Electrical installation condition - 8 October 2026

Project	Riverside Court - Cat B Fit-Out, Phase 2
Client	Halloway Cross Estates Ltd
Address	Riverside Court, 42 Kelham Street, Sheffield S3 8LP
Reference	EIC-2026-10-001
Report date	8 October 2026
Status	Draft - not yet published
Items included	12

Photograph 2 - 3 items on this photograph, 3 pins on this photograph

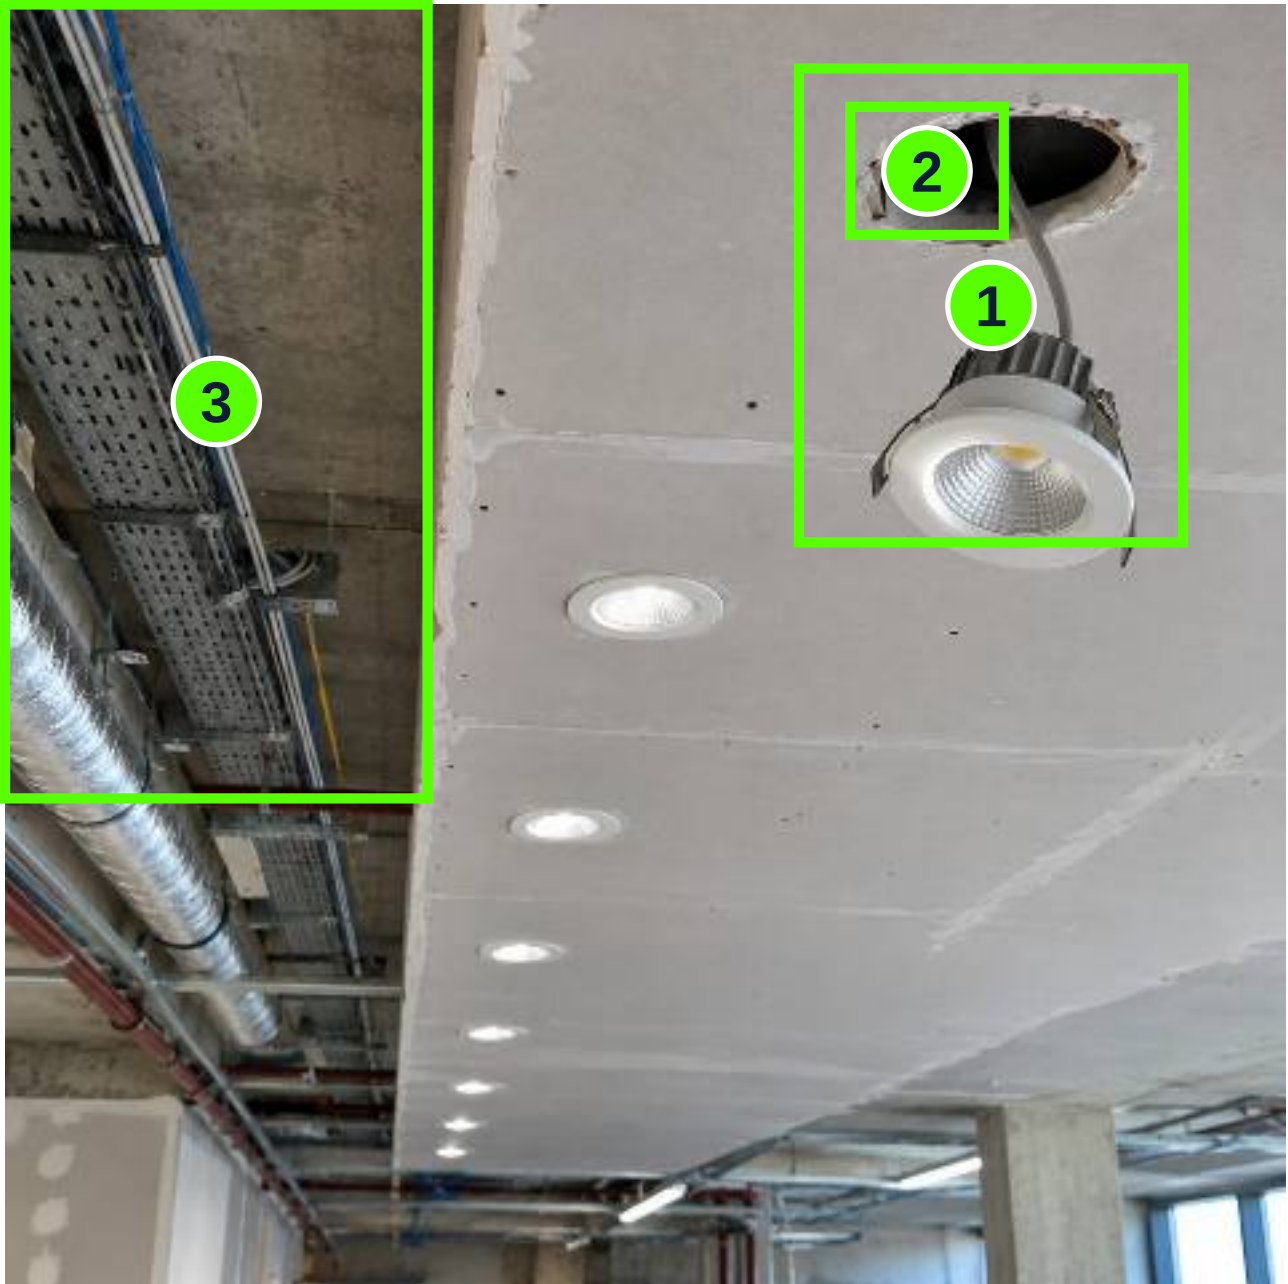
The open ceiling aperture at the same location as the displaced luminaire shows a dark void in which cable or connector is partially visible. The contents and terminations within the void cannot be identified from this image, and no judgement can be made on the enclosure or connection method from the photograph.

A recessed luminaire in the plasterboard ceiling at the upper right of the image is hanging from its aperture on a flexible cord, fully out of the ceiling void. The luminaire body carries an exposed metallic heat sink and the cord is unsupported over its free length. The unit is not secured to the ceiling, is not connected to any support or fixing, and the aperture is left open and unsealed. In this condition the luminaire is a suspended object above the working area.

Inspect the void and the terminations within it, confirm the integrity of the cable sheath and any connectors, and confirm continuity and polarity by test by a competent person before the luminaire is reinstated.

Isolate the lighting circuit and prove dead before any work on the unit. Re-seat the luminaire in its aperture with the correct retaining clips, restore the cord and any terminations, then reinstate and reseal the aperture. Verify secure fixing and correct termination by test before re-energising.

Item 1

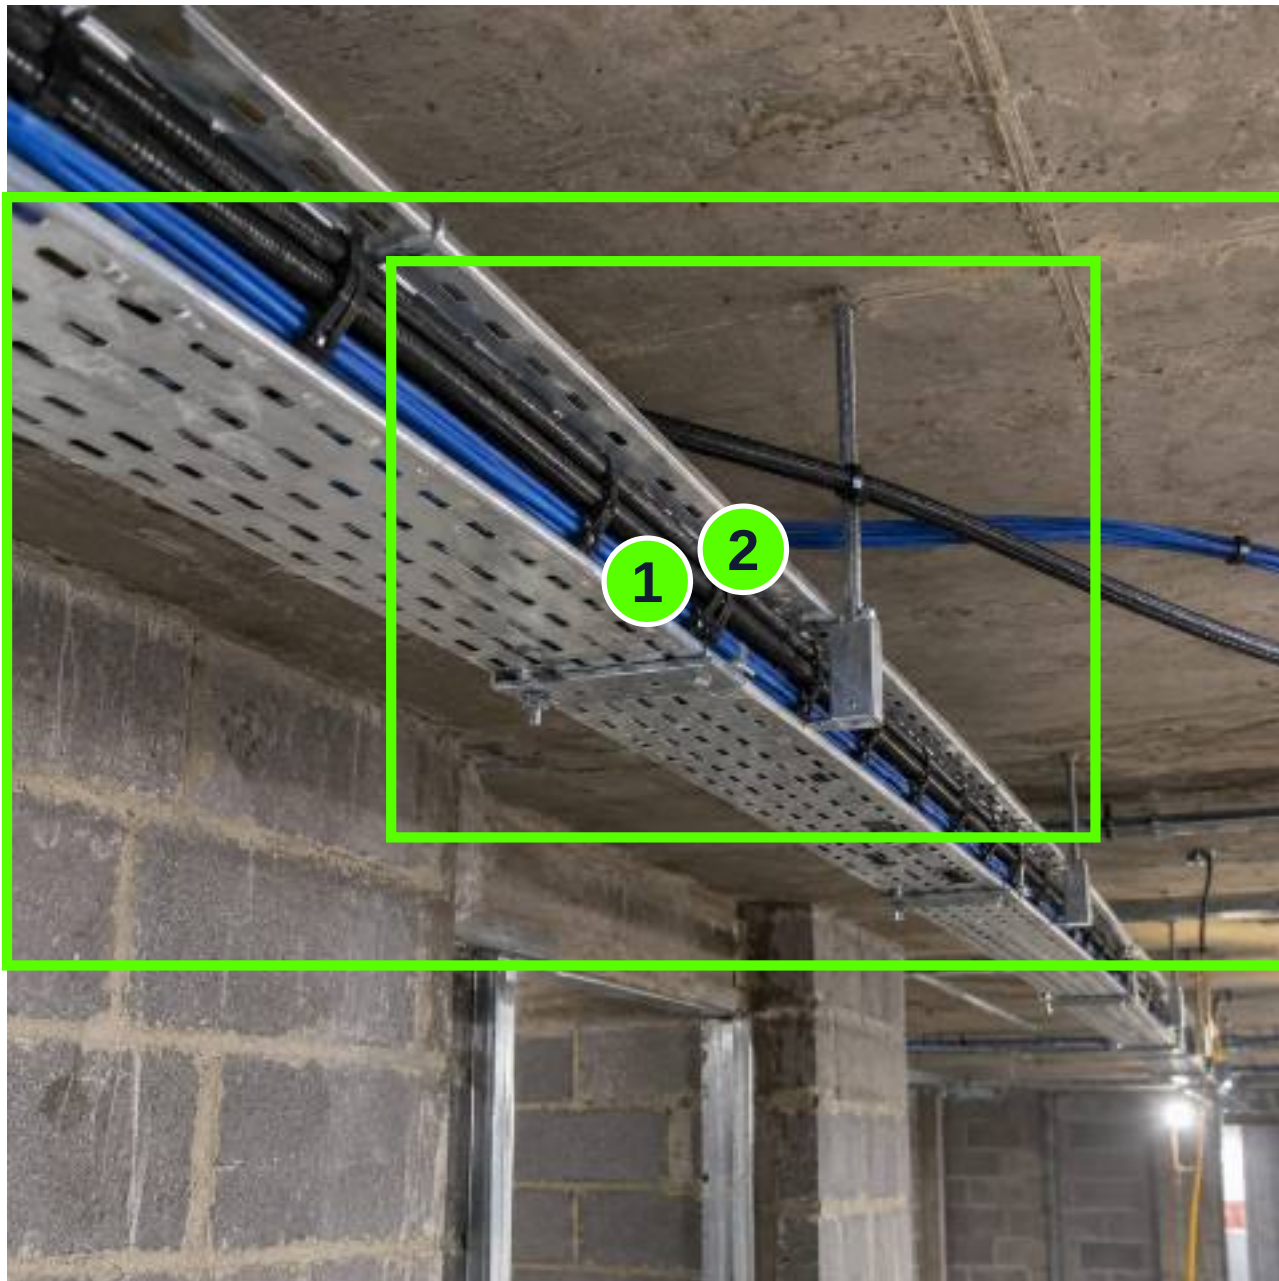
A consumer unit is mounted on a plasterboard wall with the front cover removed, exposing the busbar, neutral bar, earth bar and the incoming meter tails above the enclosure. The internal connections are visible but the cover is not fitted and the installation cannot be judged complete from this view.

Do not energise or leave energised with the cover removed. Confirm isolation and lock-off, then have a competent person refit the front cover and verify the enclosure is complete and secure before the installation is put back into service.

Item 2

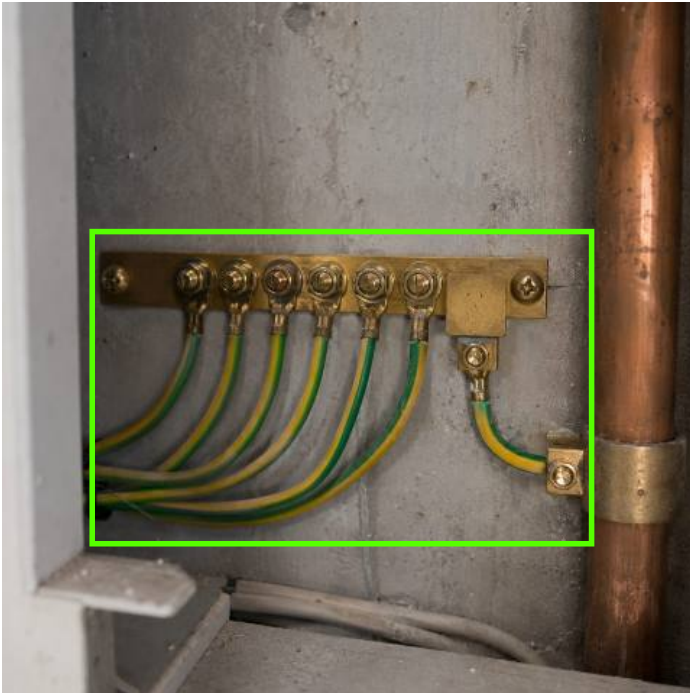
A brass main earthing bar is mounted on a bare concrete wall within an enclosure position. Six green/yellow circuit protective conductors are terminated to the bar by individual crimped lugs under set screws. A further connection is taken from a small square brass block fitted to the bar by a single bolt, and a green/yellow conductor of smaller cross-sectional area runs from that block to a brass earthing clamp on the adjacent copper pipe. The lug terminations on the bar are made at a consistent pitch and the conductors are dressed in a bundle to the lower left. The bar is fixed directly to the concrete wall face without an insulating stand-off, and the incoming conductors are not enclosed in conduit or trunking at the point where they leave the bar, so the protective conductors remain exposed and unsupported over the bundle to the left of the bar. The conductors are not individually identified by circuit.

Isolate and prove dead before any work to the bar. Re-form the conductor bundle into a defined route and secure it at regular centres to the wall or into a length of trunking or conduit, so that no protective conductor is left free-dressed. Fit individual circuit identification to each protective conductor by durable numbering or ferruling, and record the conductor sizes and the earth fault loop impedance readings in the schedule of test results. Confirm the continuity of every protective conductor and the main protective bonding connection by test, issued by a competent person on a certificate.

Photograph 7 - 2 items on this photograph, 2 pins on this photograph

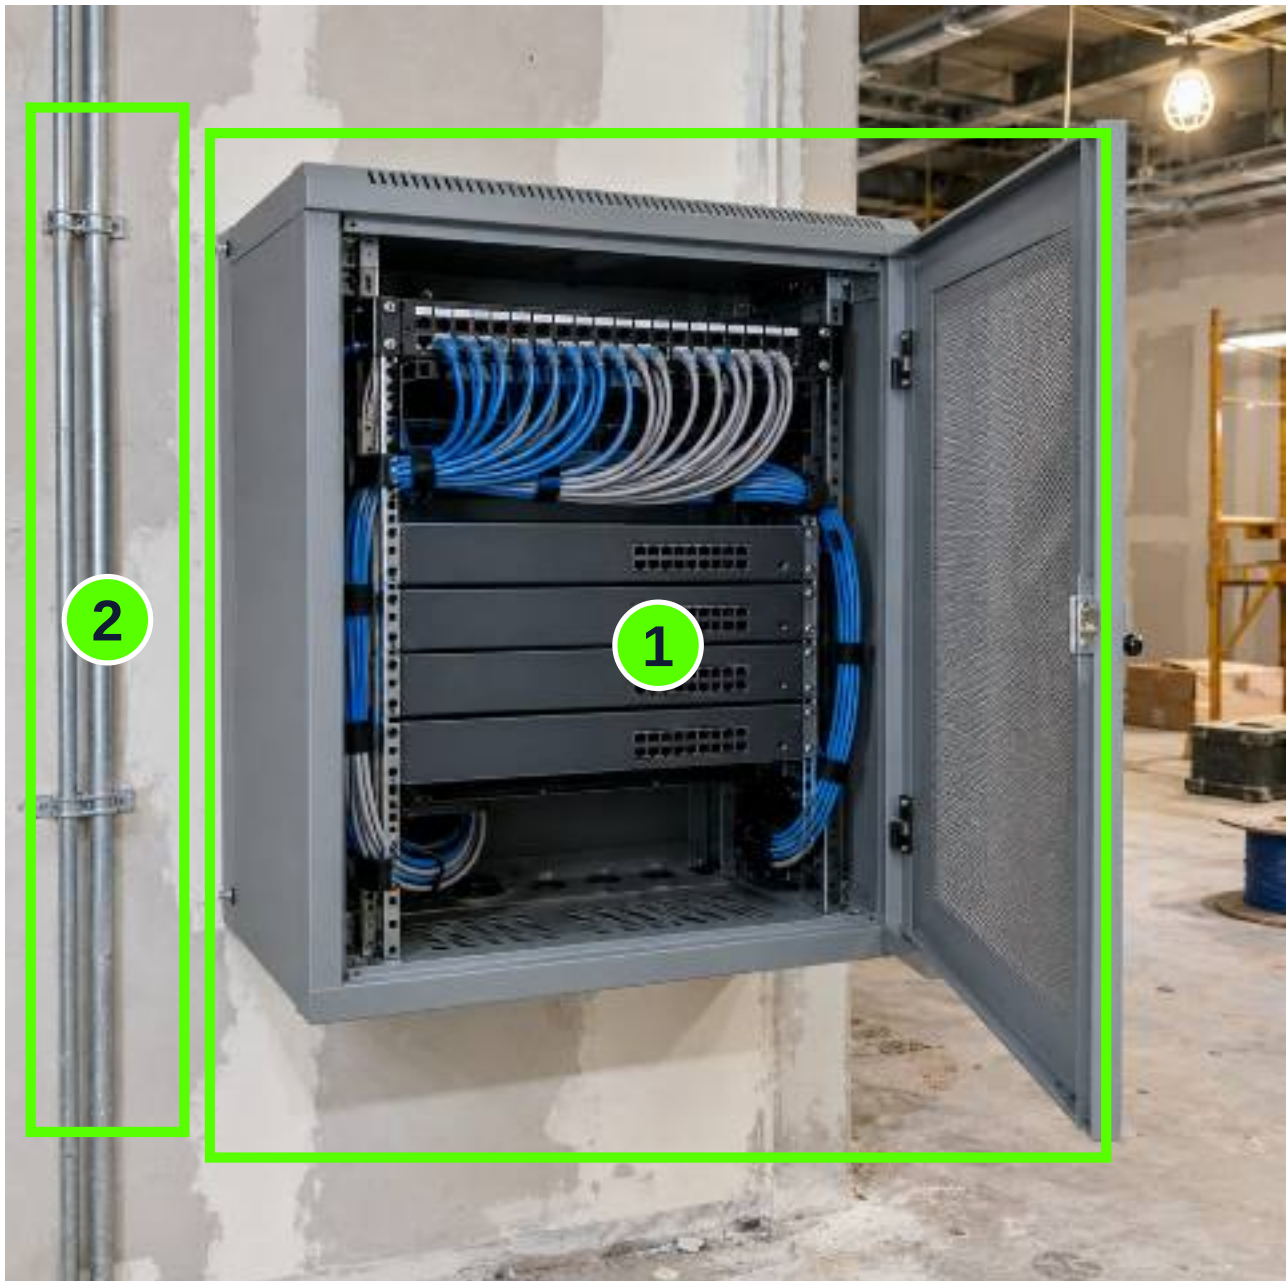
A wall-mounted steel communications cabinet is secured to a plastered wall with its mesh door open and undamaged. Data cabling within the cabinet is dressed with hook-and-loop ties and formed into a service loop. The cable management is neat, terminated and complete, and no exposed live conductive part is visible. The cabinet is a communications enclosure rather than a power distribution board, and no mains intake, protective device or earthing arrangement is visible within it.

A galvanised steel conduit drop is fixed to the plastered wall to the left of the cabinet with two metal saddles, secured with visible screw fixings. The conduit run terminates below the level of the cabinet without a visible coupling, draw box or terminating accessory at the point shown, and its relationship to the cabinet is not evident from the photograph. The containment is supported and undamaged; the termination of the run cannot be confirmed from this view.

Confirm the cabinet is correctly identified and that any metallic enclosure is bonded and earthed by a competent person, and verify the supply and protective device arrangement. Testing and certification by a competent person are required before the installation is signed off.

Inspect the full conduit run and confirm it terminates in an appropriate accessory and enters the enclosure or equipment correctly. Rectify any open end or unsupported termination. Testing and certification by a competent person are required where the run carries mains conductors.

Item 12

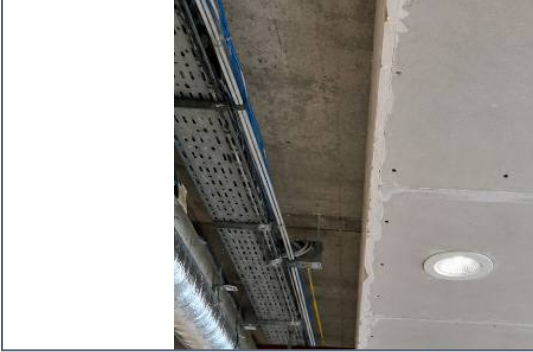
To the left of the image, cable tray and basket containment are installed at high level above the ceiling line, carrying services in a runs arrangement with drops to plant. The containment is supported at regular intervals and the cable runs within it are laid in an orderly manner. No defect in the containment or its support is apparent at the distance shown.
